STAFF REPORT TO THE PLANNING COMMISSION

SUBJECT: Rancho Meadows Project Preliminary Development Plan (PRE2023-0002)

Re: **Engineering review of the Preliminary Development Plan for Rancho Meadows, "Vineyards and Santa Fe Property"**

Sheet 1 – Site Plan

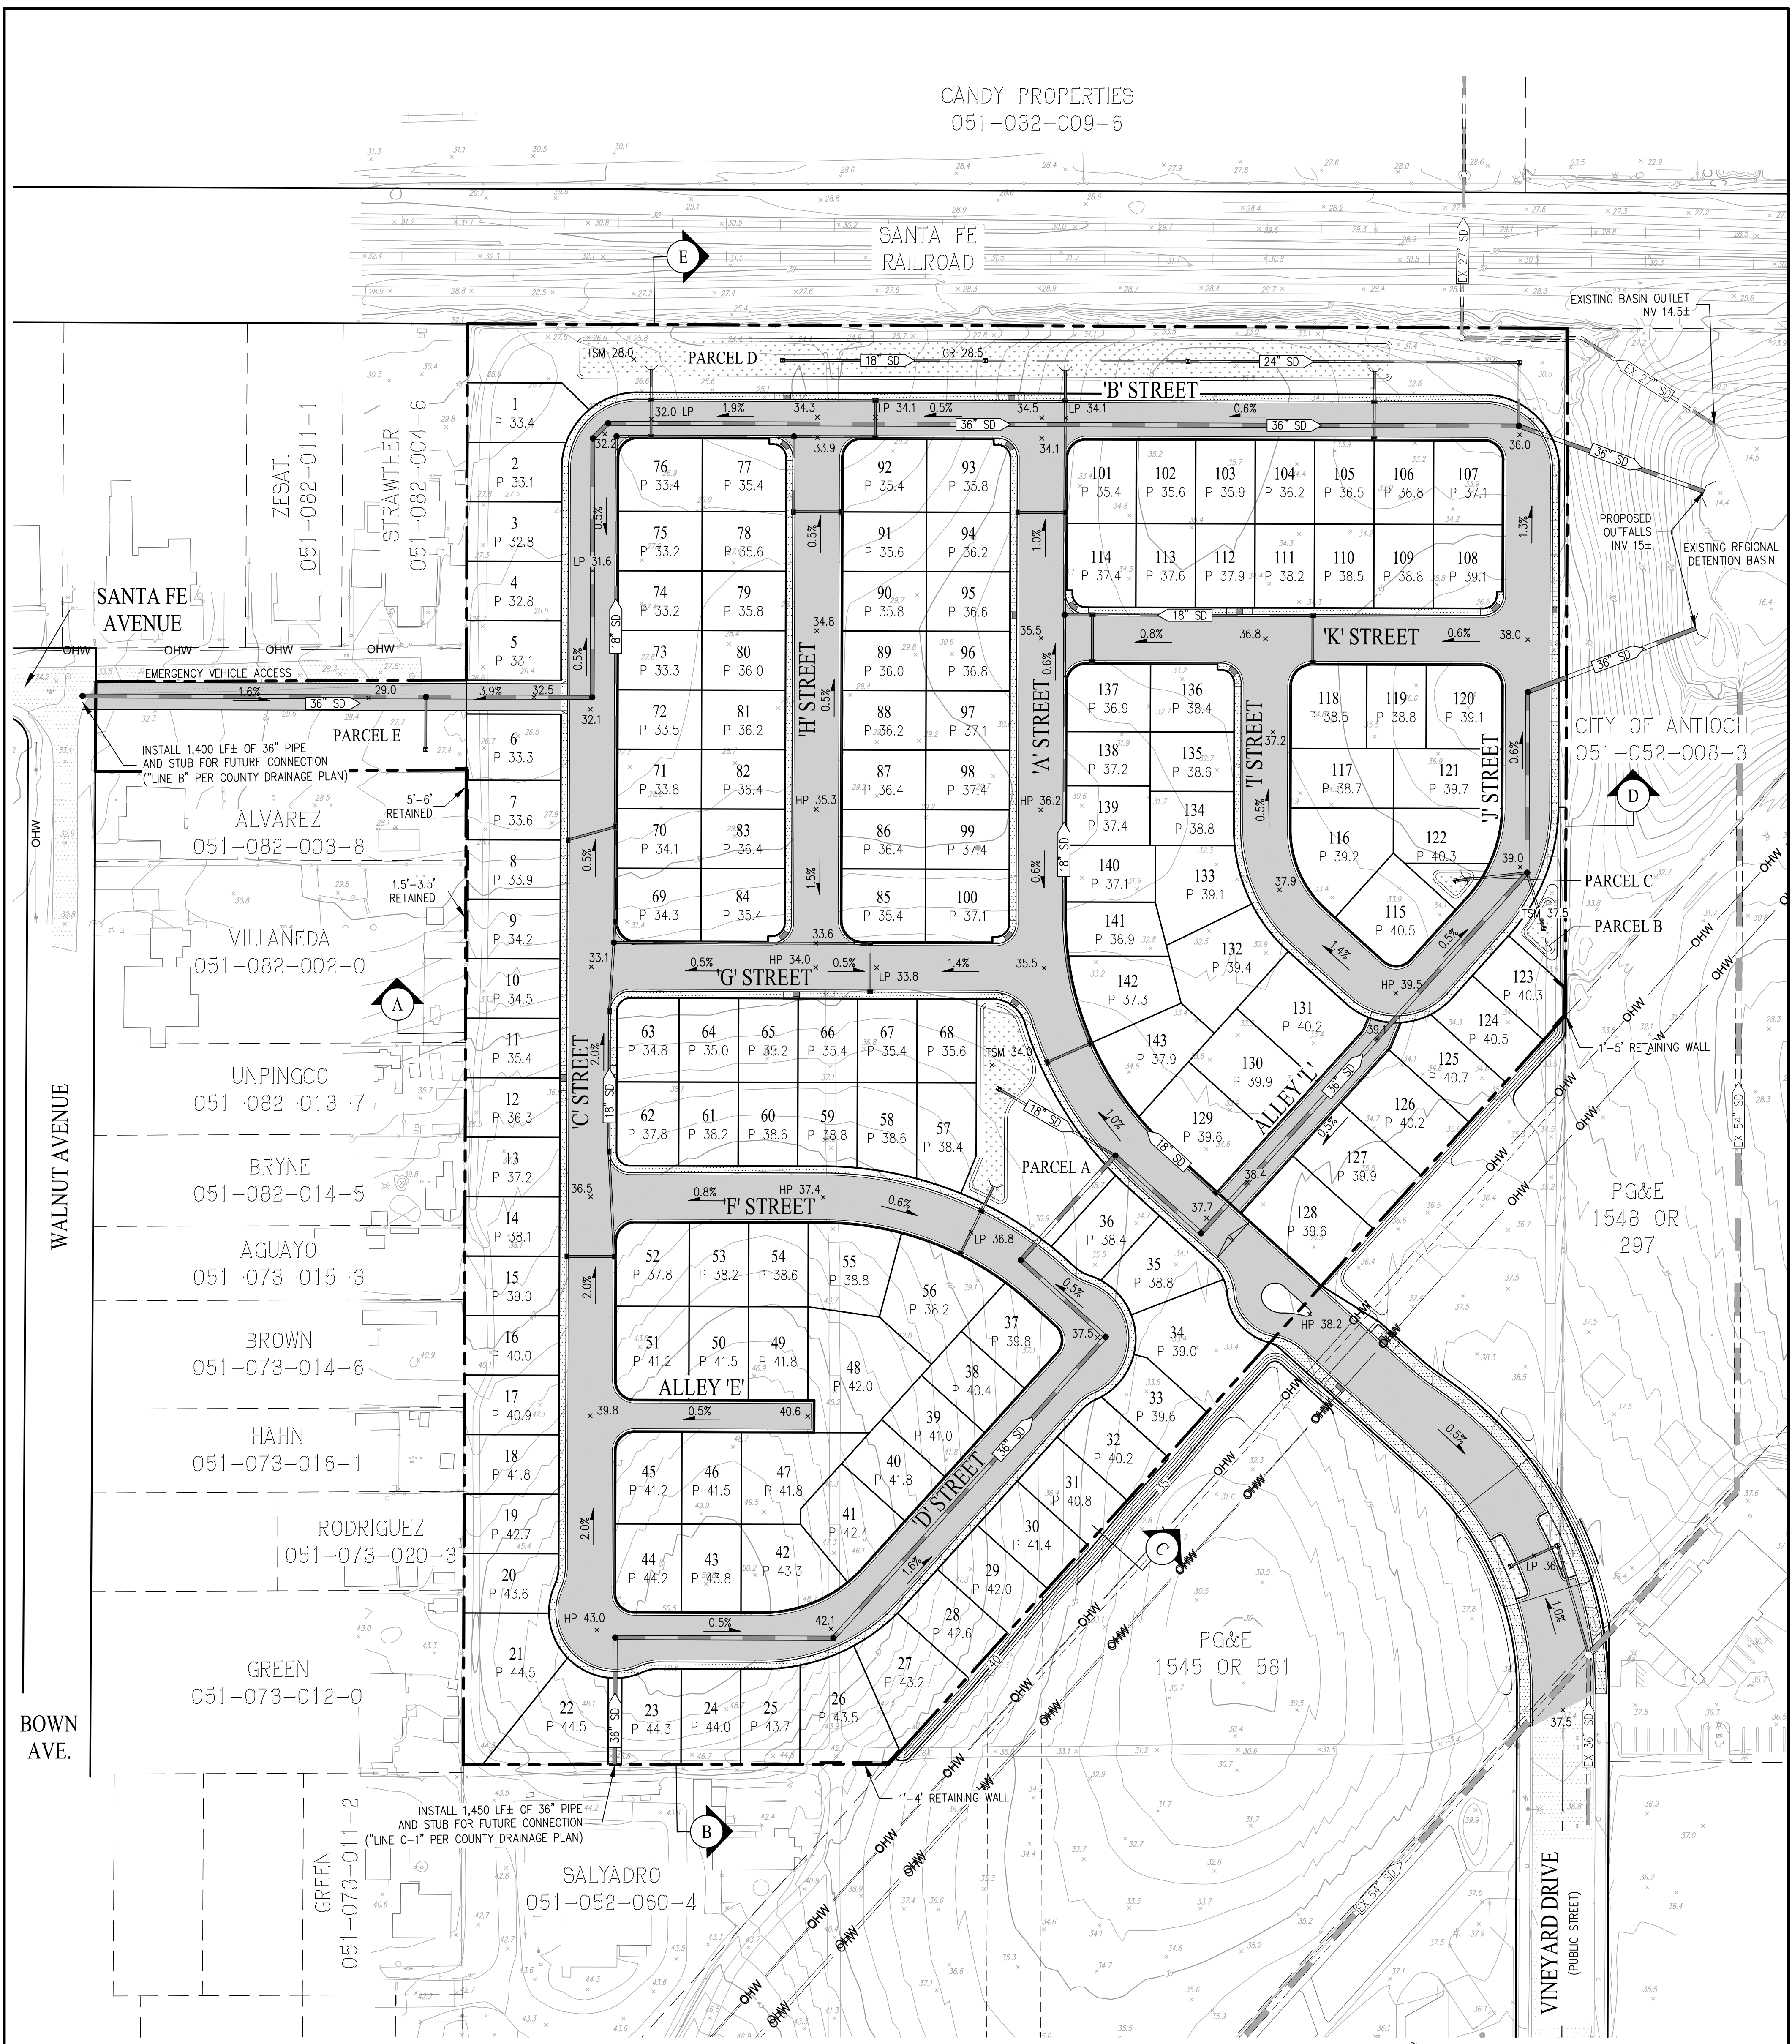
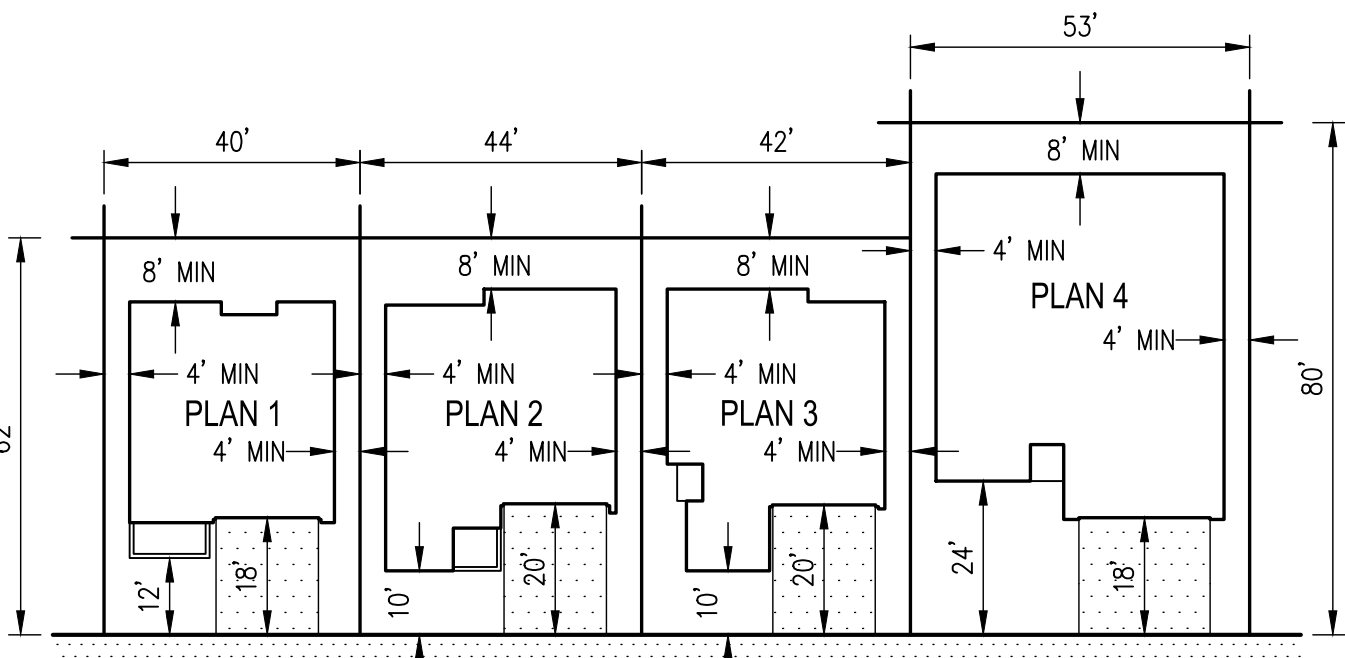
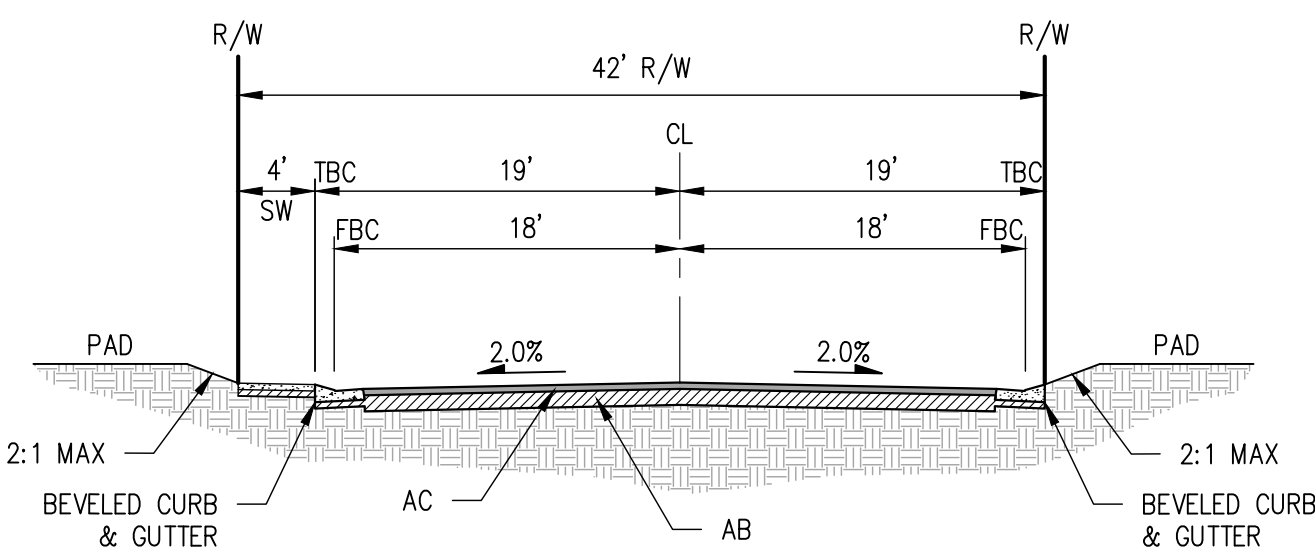
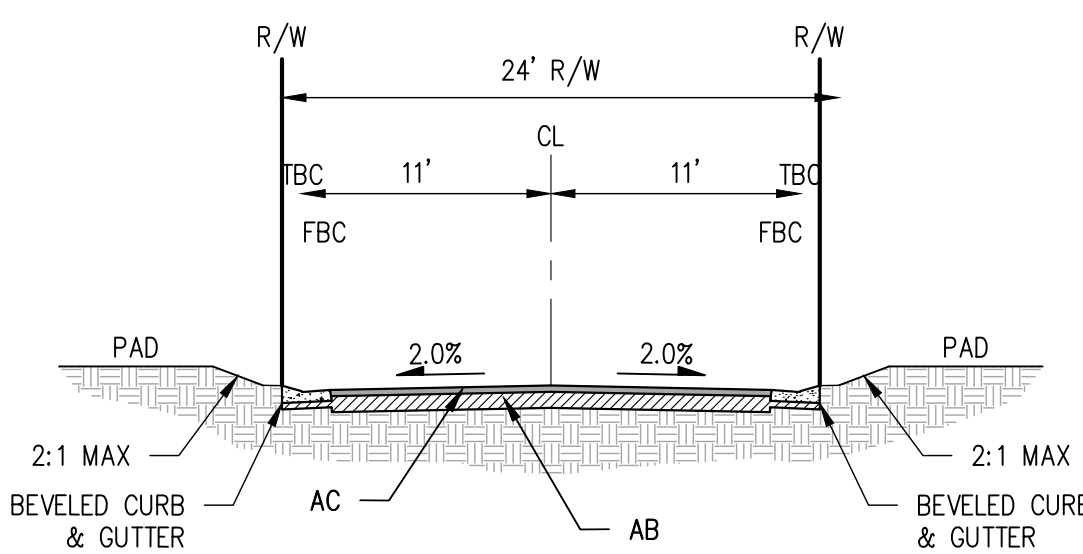
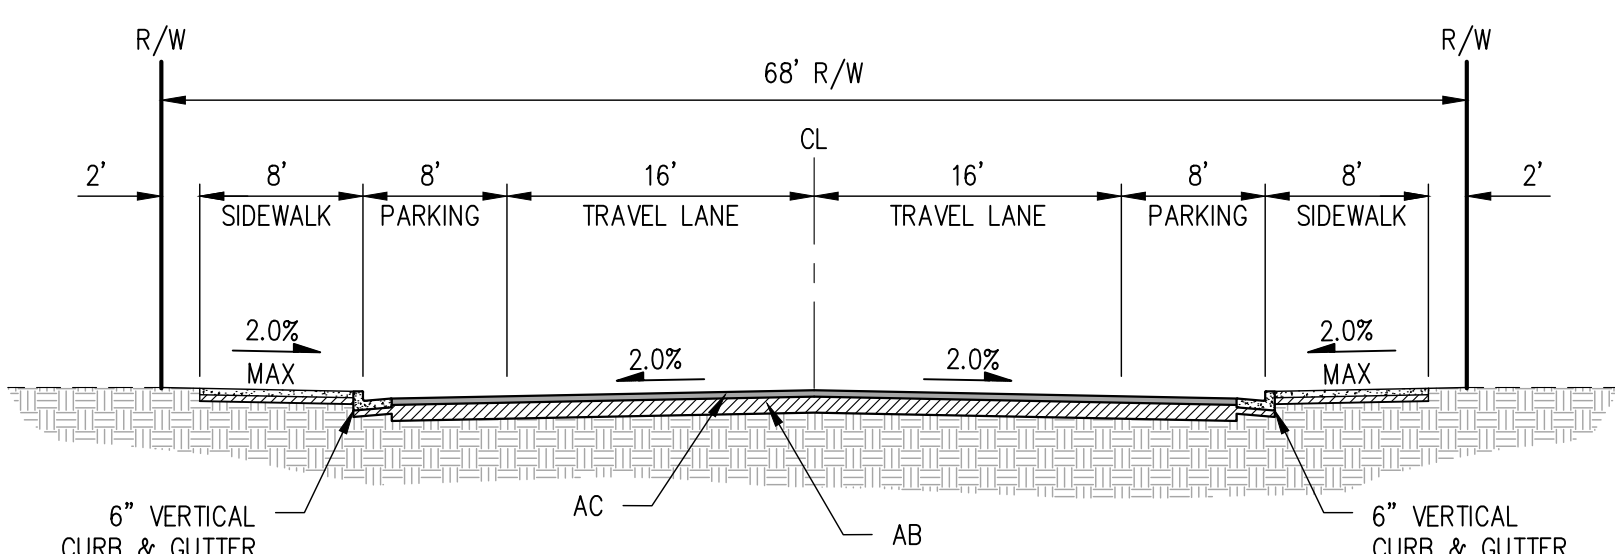
6. Ensure all residential lots **have proper sight distance** of 25 feet at their driveways and all intersections provide proper sight distance of 50 feet at each corner per AMC § 9-5.1101 on a separate diagram.
7. Reconfigure or relocate the entrance island to the property so emergency vehicles (fire truck) and moving trucks can pass through without hitting the island in either direction.
8. Please provide sidewalks in front of all residential lots, provide ADA ramps at corners of street intersections, and show crosswalks along the residential lots that are needed for access to parks or any other amenities. Sidewalks help improve the proper line of sight

9. Please provide increased bulb out pavement all streets with a 90-degree bends. Please demonstrate on every street bend how a SU 50 truck and a 40' bus Design vehicle per Caltrans Highway Design vehicle will not hit park cars along the curbs or hit other passenger cars trying to make the same turn from the opposite direction.

12. Please show how the proposed lot dimensions are consistent with those required for similar density development, but may be acceptable for this planned development, see AMC § 9-5.601.

14. Include the calculations for the minimum required open space, see AMC § 9-4.1001.
15. Please provide documentation rolled curb detail to be used within the project.

16. Please provide landscaping of the area south of EVAE access to Walnut avenue from the development. Suggest this area could be used as pocket park or open space.
